To: Sam Hubbard, Development Planner, Planning and Community Development
From: Deb Pierce, Plan Reviewer, Building & Life Safety Department
Subject: 1650 W Algonquin Rd – 7-11 Gas Station & Convenience Store – SUP for Gas Station
PC#: 18-026 – Round 1
Date: Dec. 28, 2018

PLAN COMMISSION PC #18-026
7-11 Gas Station and Convenience Store
1650 W Algonquin Rd
SUP for Gas Station
Round 1

December 21, 2018

Project: 7-11 Gas Station
1650 W. Algonquin Rd.

FIRE ENGINE TURNING TEMPLATE

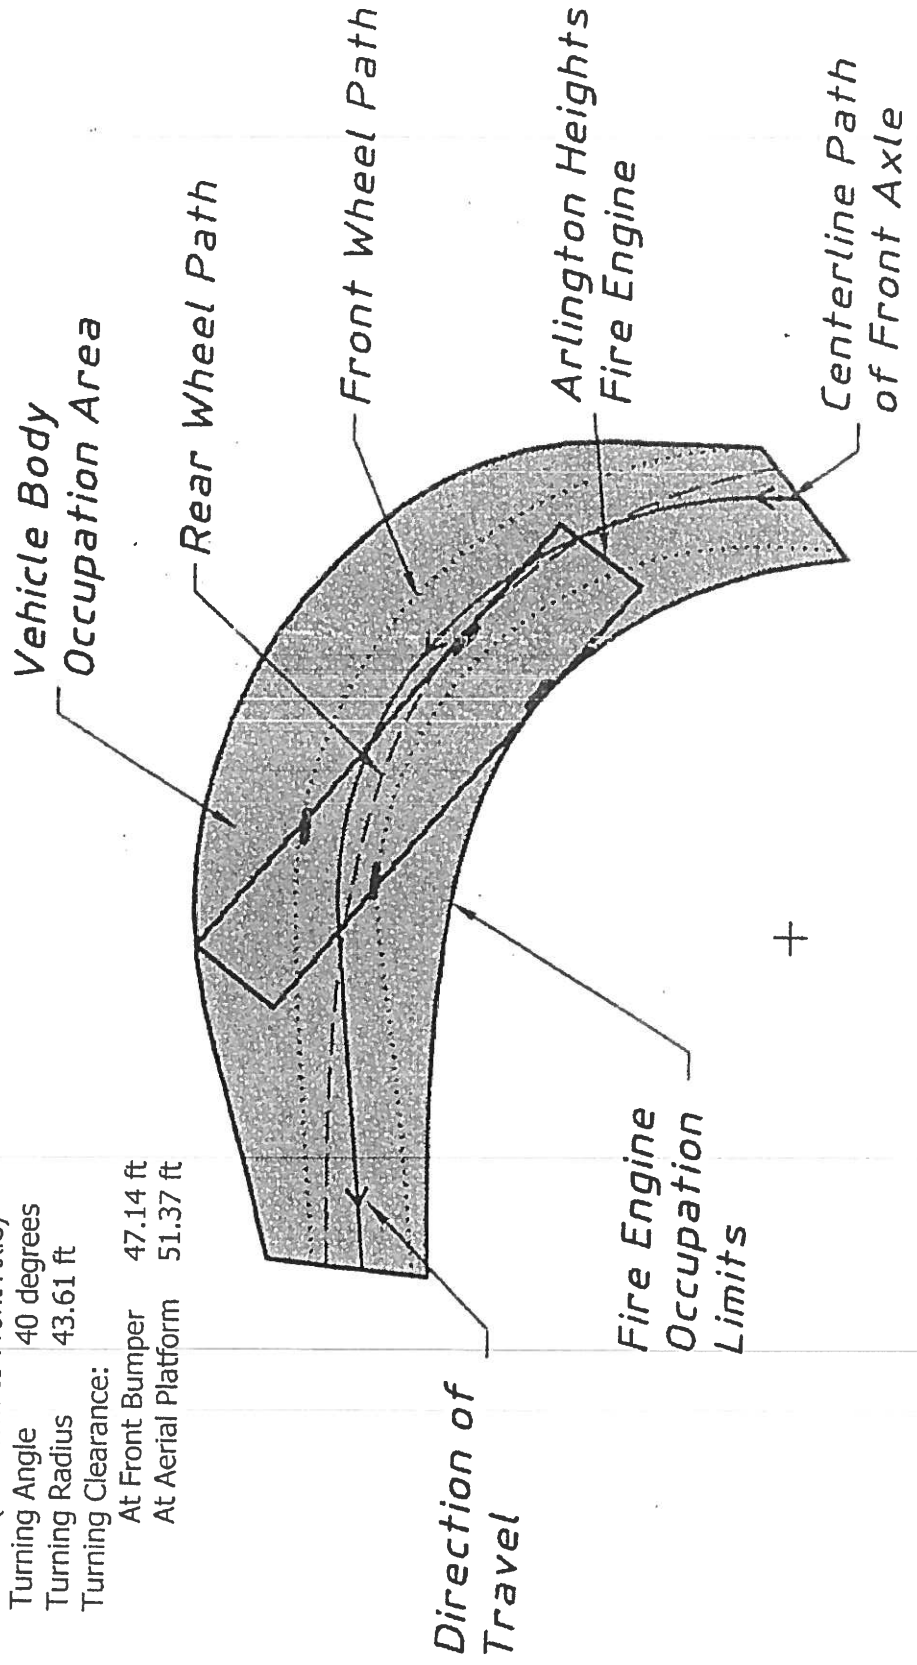
16. Provide an exhibit to engineering scale showing the turning path of the Fire Department's responding vehicle, in this case the tower truck. Exhibit must show front and rear wheel paths and the extent of the front and rear overhangs, as provided in an "Autoturn" exhibit. The vehicle shall be shown maneuvering through the site in all possible directions of travel. Attached are the specifications for the tower apparatus.

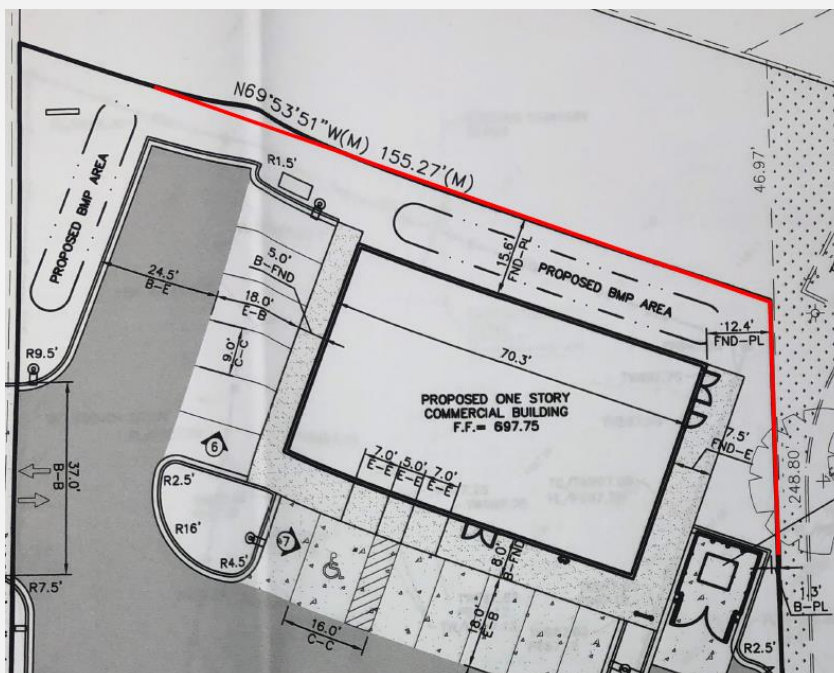
19. In anticipation of the future right-turn lane along Algonquin Road, please revise the site plan to push the curb line

along the west, southwest, and south as far in as possible while still preserving adequate space for vehicular access and circulation. Please see the exhibit below for clarification.

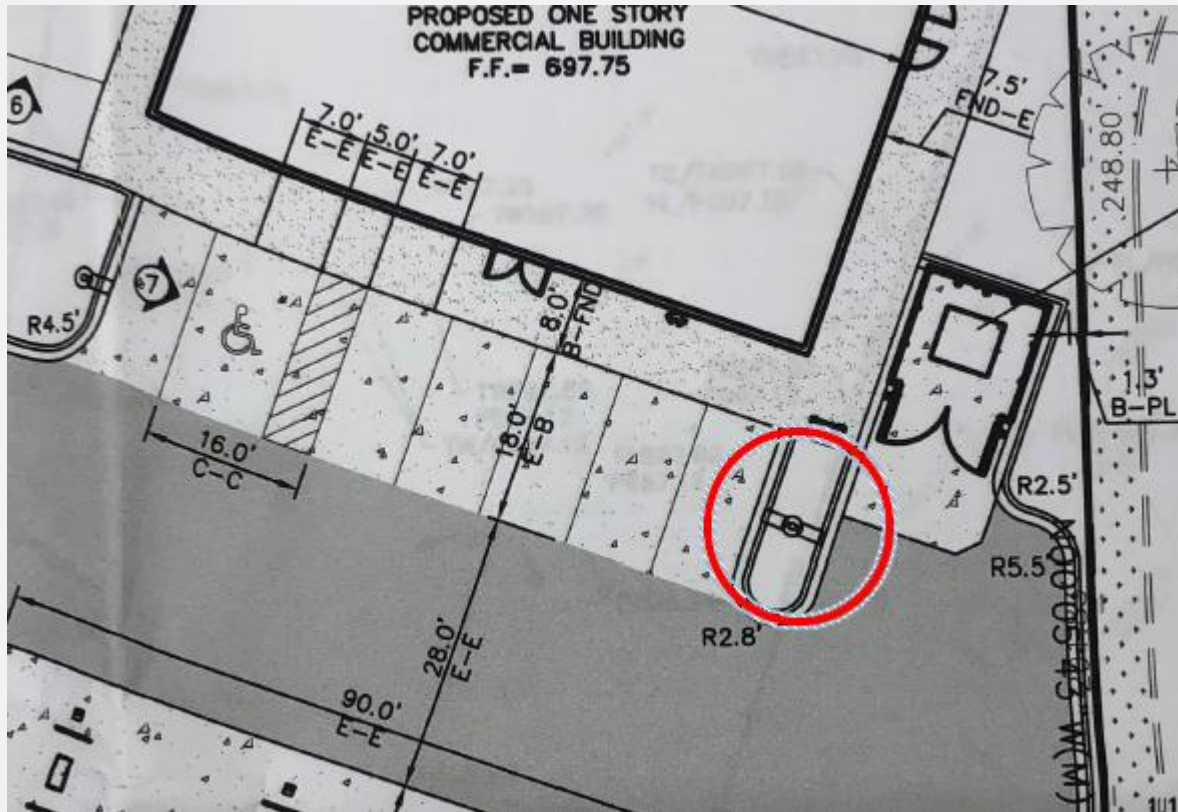
20. Due to concerns from the neighboring residential property owners to the north, combined with the fact that the proposed plan reduces the greenspace/buffer that currently exists at the north of the property, it is recommended that a 6' tall solid fence be provided as indicated below.
